## 1806 Scott Street

Planning Rationale Addendum  
Zoning By-law Amendment + Site Plan Control  
September 5, 2023

Prepared for 2851944 Ontario Inc

Prepared by Fotenn Planning + Design  
396 Cooper Street, Suite 300  
Ottawa, ON K2P 2H7

Figure 7: Proposed building design for Submission 2, looking south toward Scott St

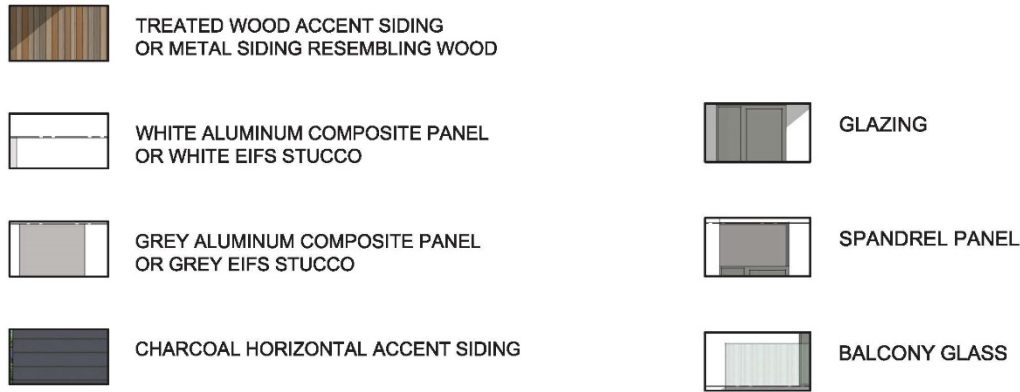
In response to feedback from the public, the building design has been adjusted to introduce additional colours to the ground floor, including a charcoal horizontal accent siding, shown below in Figure 7 and Figure 8. The charcoal siding emphasizes the ground floor and provides a transition in materials to add visual interest and break up the massing of the building.
